North Liberty City Council
Work & Regular Sessions
February 27, 2018

City Administrator Memo

ICCSA Christine Grant Elementary Site Plan

Grant Elementary Site Plan

Figure 8 Pedestrian Activated Flashing Yellow Beacon and Pavement Markings

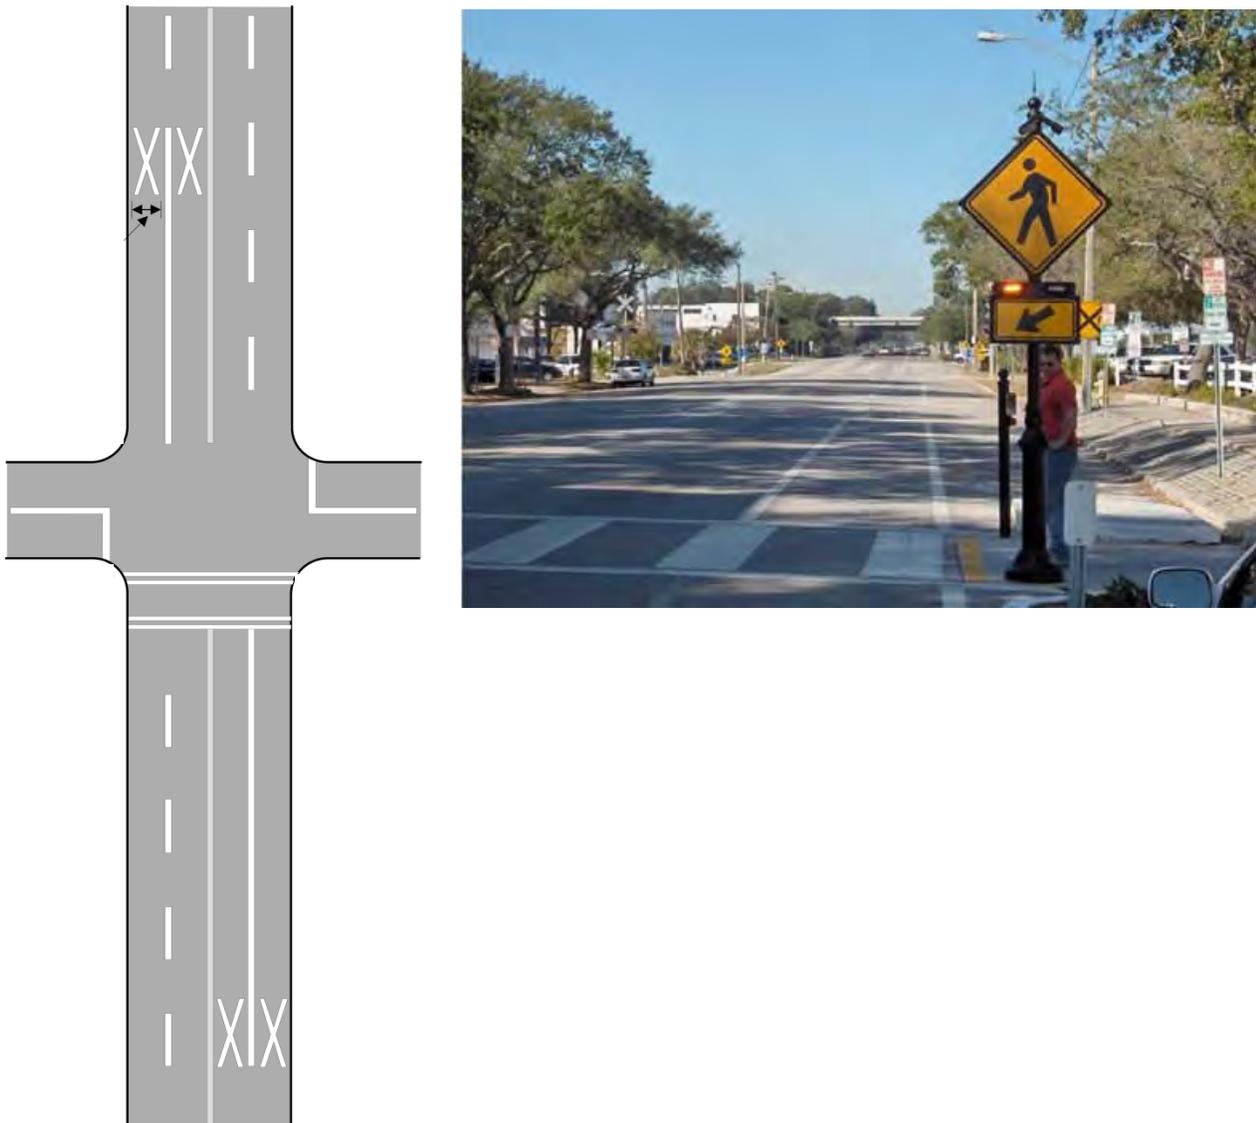
Pedestrian activated flashing yellow beacons with overhead signs and advanced pavement markings were also considered for the intersection of Penn Street and Dubuque Street/Stewart Street. This treatment is used to alert drivers to pedestrians who may be crossing the roadway. The pavement markings consist of a large white "X" in each traffic lane. The "X" is 20-ft long and each line is 12 to 20 inches wide. The "X" is positioned approximately 100 feet in advance of the crosswalk, which should be at least 8 feet wide with edge lines 6 to 8 inches wide. The Highway Safety Manual states this treatment may decrease pedestrian fatalities. However, the magnitude of the crash effect is not certain. Figure 8 illustrates the pavement markings and pedestrian activated flashing yellow beacon. This treatment would not be appropriate for the intersection of Penn Street and Front Street. This treatment is intended to be used at minor stop controlled intersections with a pedestrian crosswalk extending across the major street, for example Penn Street and Dubuque Street/Stewart Street.

- Install a pedestrian activated flashing yellow beacon and pavement markings as illustrated in Figure 8.
- Relocate the school crossing sign currently on the southeast corner to the southwest corner. This would alert eastbound traffic to the crosswalk in advance of the intersection.
- Maintain visibility of the crosswalk markings by regularly repainting them.
- Coordinate with the owner of 210 Penn Street (house on the northeast quadrant) to address sight distance concerns caused by shrubs.

Figure 9 Study Intersections – Recommended Lane Configuration and Control

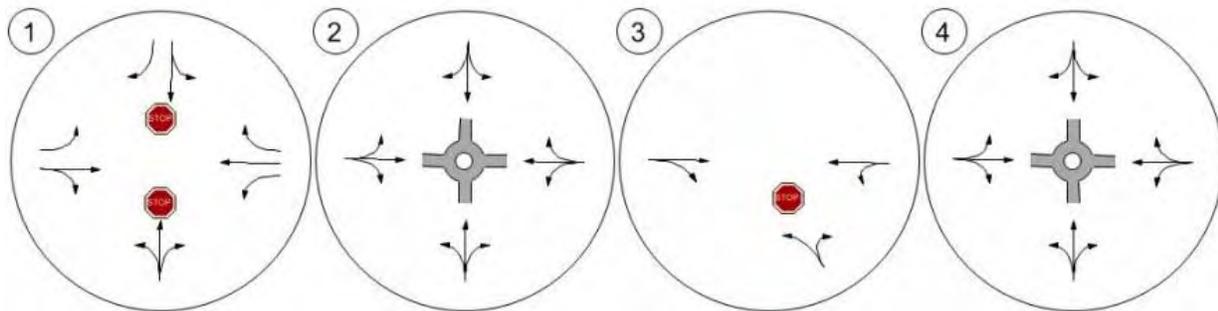
Recommended geometric configurations at the study intersections are presented in Figure 9. Conceptual drawings are provided in Appendix 5.

18 PARKING
SPACES ADDED

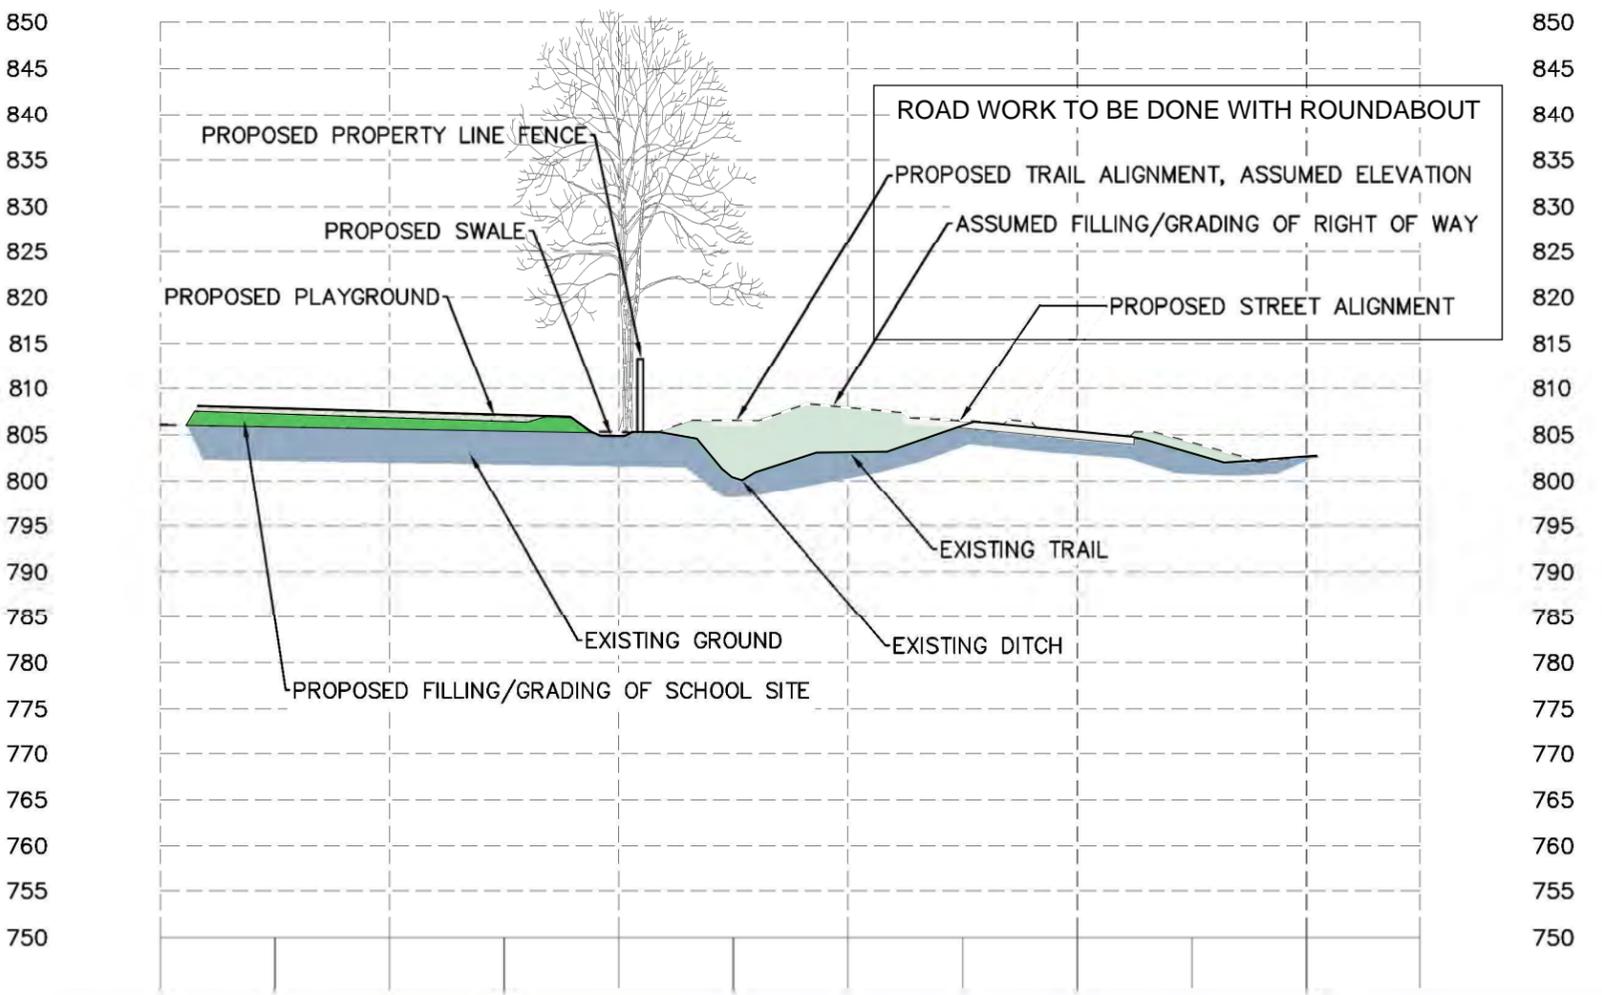
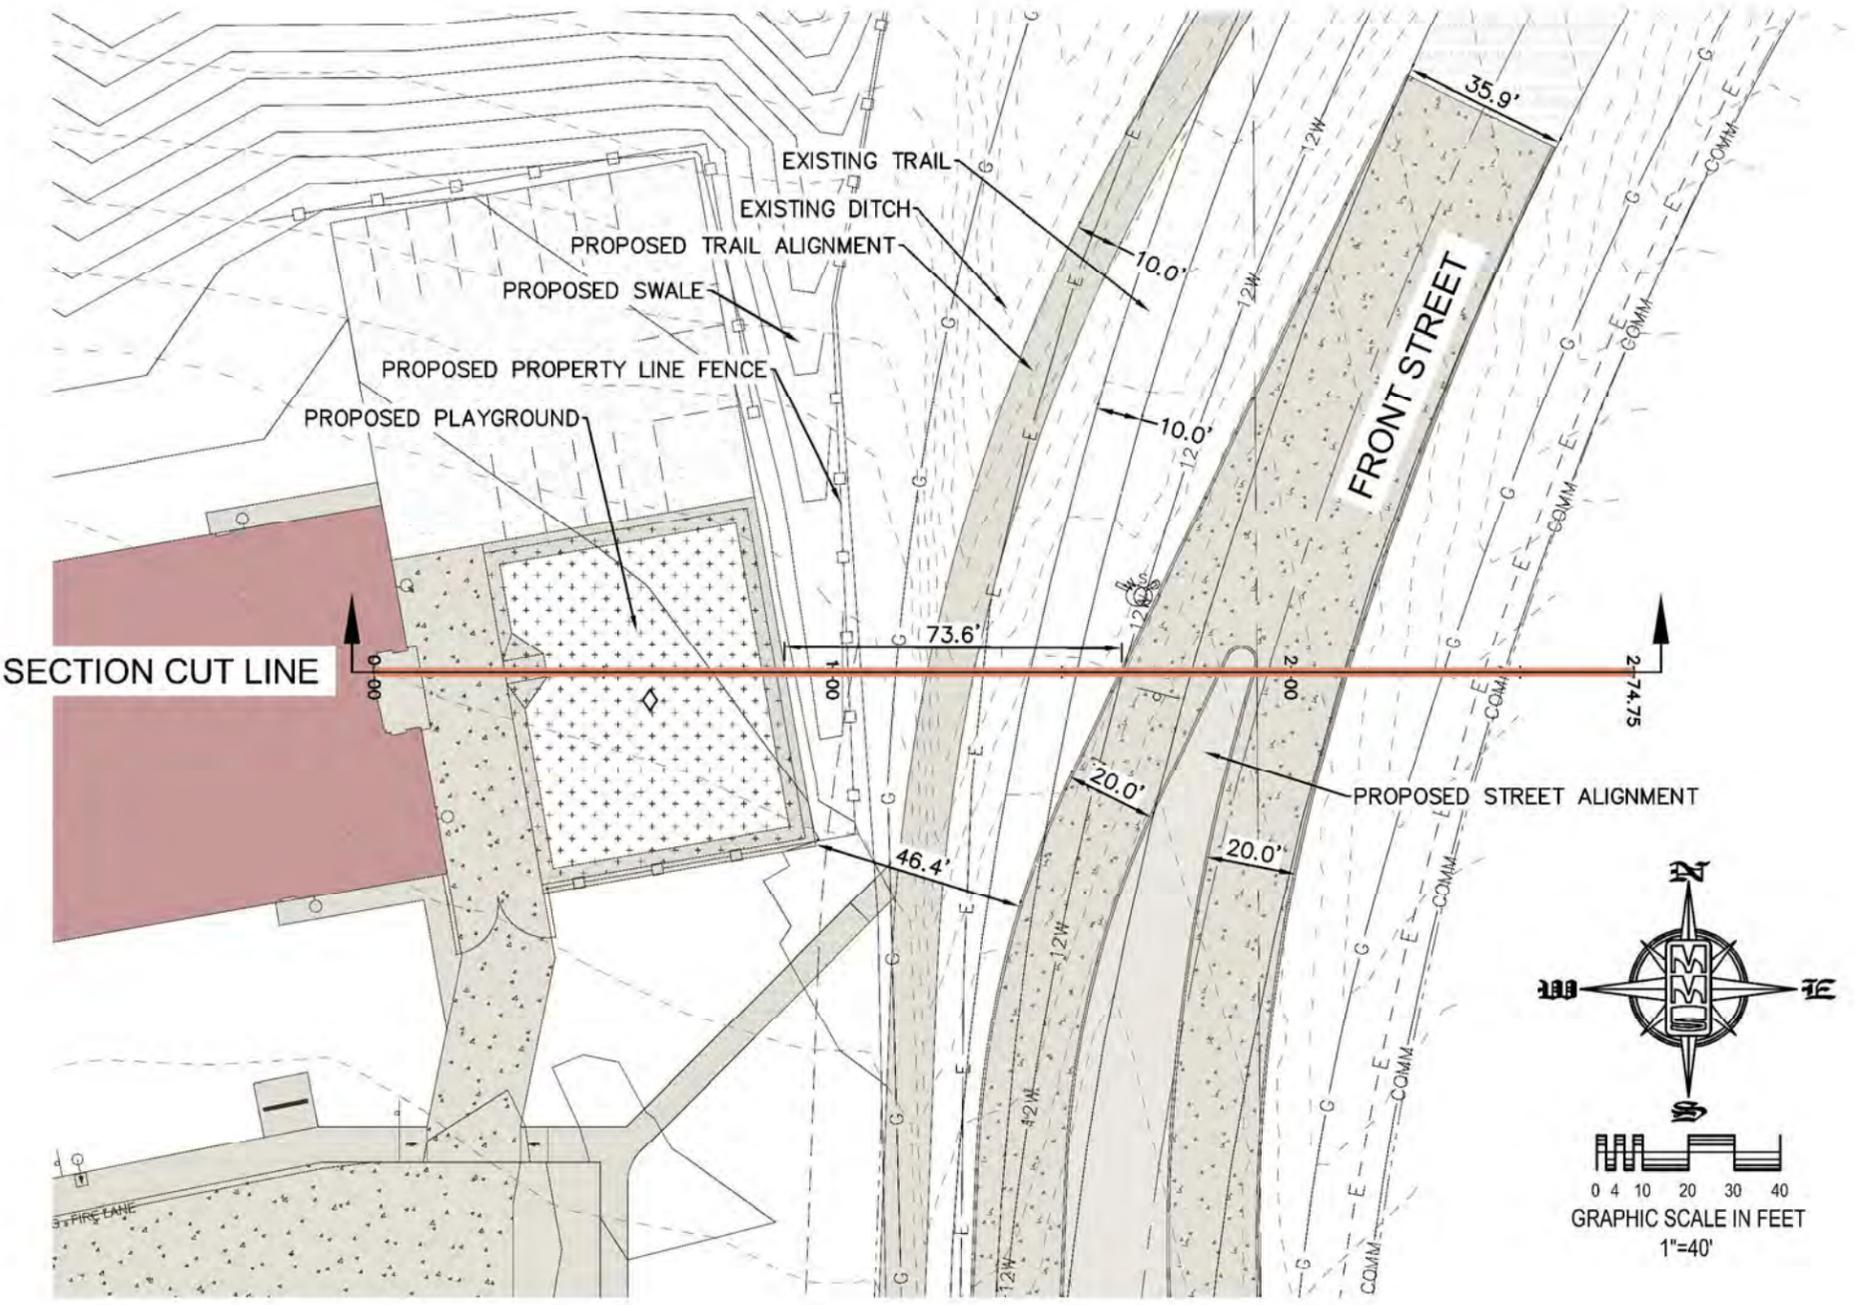
We have also provided two attachments for your consideration. The first is a proposed revision to add 18 staff parking stalls along the west side of the school bus drop-off lane. The second attachment is a cross-sectional diagram showing the relationship of the Pre-K playground area and Front Street. The actual changes in topography, the distance between the playground and the roadway and the proposed construction of a proposed landscape berm and fencing, we believe would make it very unlikely that a vehicle leaving the roadway would be unable to, if not virtually impossible, impact the playground or safety of the students.

TREES ADDED
ALONG
PLAYGROUND /
FRONT STREET
RIGHT-OF-WAY
